(CDP 5-23-0346, Tabazadeh)

CORRESPONDENCE

Re: Application 5-23-0346

RE: June 12, 2024 hearing item w13a-6-2004, Application No. 5-23-0346

SITE PLAN
 SCALE 3/32"=1'-0"

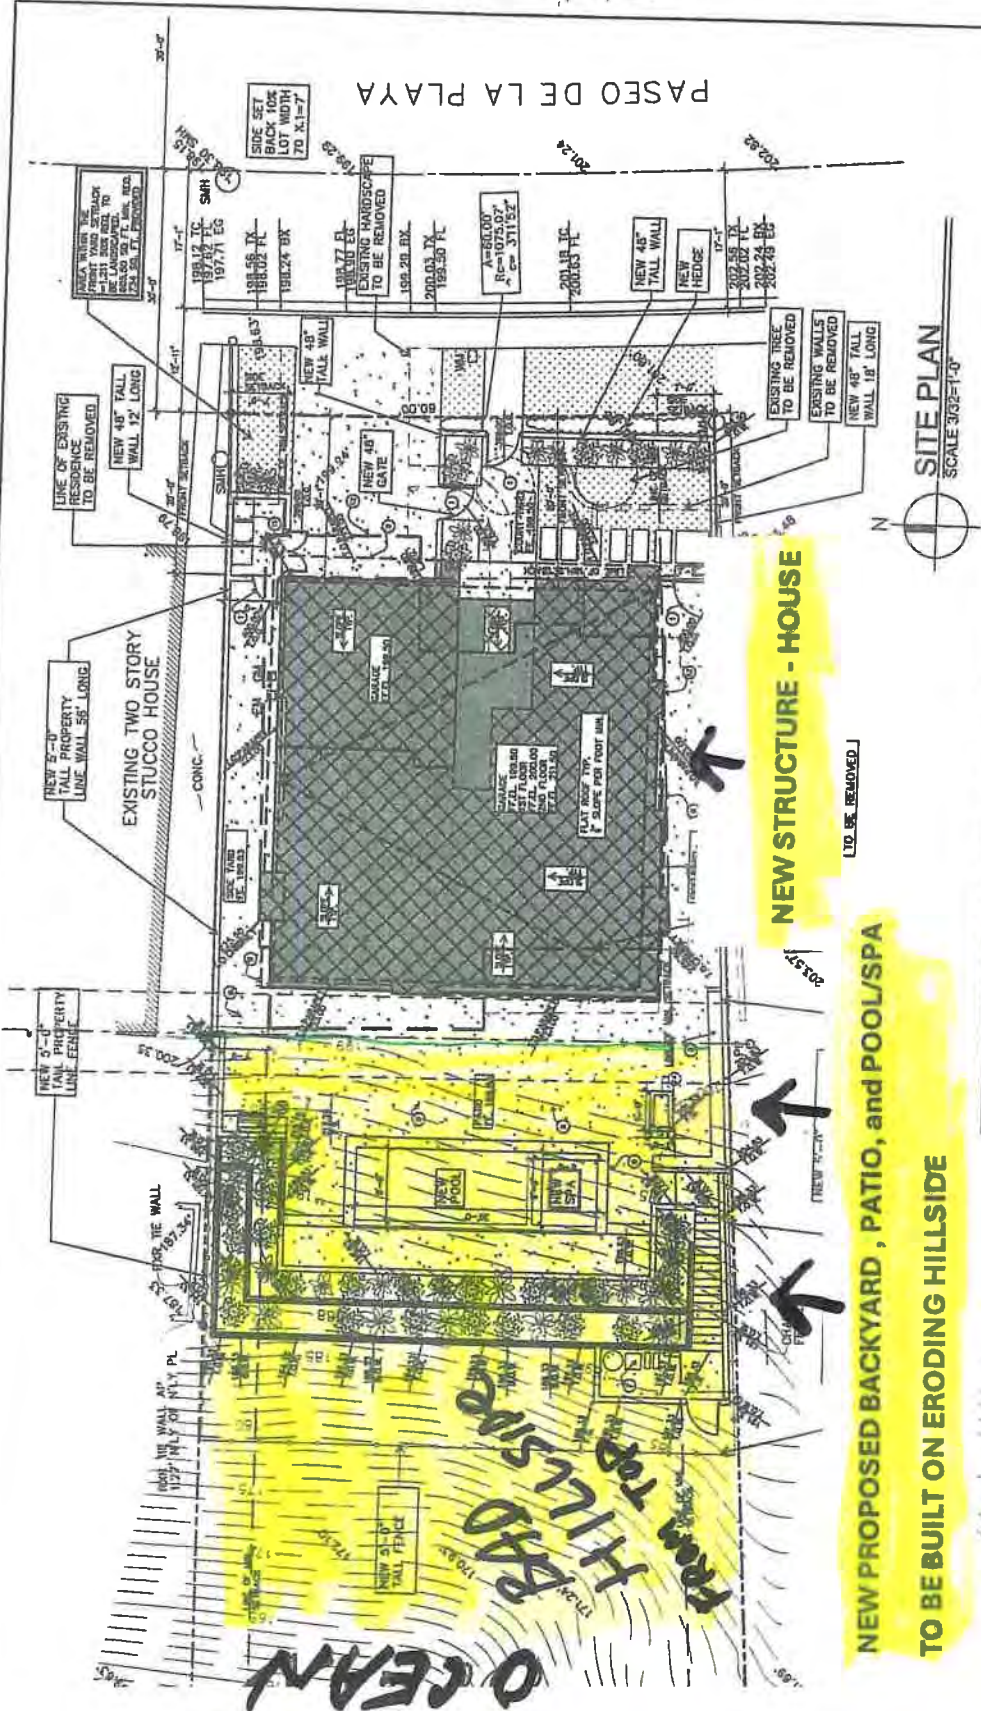
Our concerns are that the applicant has plans to build a Patio, deck, and spa/pool in the rear of the new structure on a very eroding, unstable hillside (See exhibits #1, #2, #3).

This area is very fragile and consists of loose sand that is only held together by vegetation and iceplant. If this vegetation is removed or any weight put on the hillside, it will cause a landslide for sure.

Our house and property is directly adjacent north to this property, and we have noticed erosion below our patio on our little grassy area and know the area well and how unstable it is. By adding the weight of a pool, deck and patio, we are concerned about losing the whole hillside and affecting our property too.

We would like to suggest that the drainage issues be resolved and repaired first before the Commission grants permission to build the deck, patio, and pool on the hillside, and that appropriate tests are done to make sure the hillside can handle the weight and construction. Many reports have been filed, but none of them address adding additional weight to the hillside. We would also like to request that if any landslide or collapse during construction of any portion of this project, causing damage to our property at 501 Paseo de la Playa and adjacent hillside, that the applicant, Mr. Tabazadeh, be responsible for any damages.

NEW PROPOSED BACKYARD, PATIO, and POOL/SPA
TO BE BUILT ON ERODING HILLSIDE

Rear area of house (west side) to ocean. Proposed plans include a new deck, pool and spa. This hillside is eroding and collapsing monthly and ANY disruption will almost certainly cause a landslide which will also affect neighbors properties to the north and south. Also, any large bulldozers or any extra weight of a larger house might also cause the hillside to collapse.

The Applicant's proposal does not include the pool or planters shown in the DundeEs' submission, and the area of development shown in their letter does not reflect the current scope of the project. The proposed development is shown in Staff Report Exhibit 2 – Project Plans – Residence and will be located 25 feet from the top of the bluff.

With regard to bluff stability, the Applicant's Geotechnical Engineer, T.I.N. Engineering Company, determined that the proposed development has a calculated global static factor-of-safety (FS) of 1.5, which is the standard that the Commission typically requires for new principal structures. The scope of the geological investigation involved exploratory borings, specific field soil logging and sampling, laboratory soil sample tests, and engineering analyses. The study included review of the available project data, historic aerial photographs and topographic maps, site geologic reconnaissance, past Commission Bluff Edge Determination memos, as well as calculation of long-term bluff retreat rates and engineering slope stability analyses. Commission staff Geologists Dr. Joseph Street and Philip Johnson reviewed the soil investigation and determined that the bluff slope will be adequately stable.
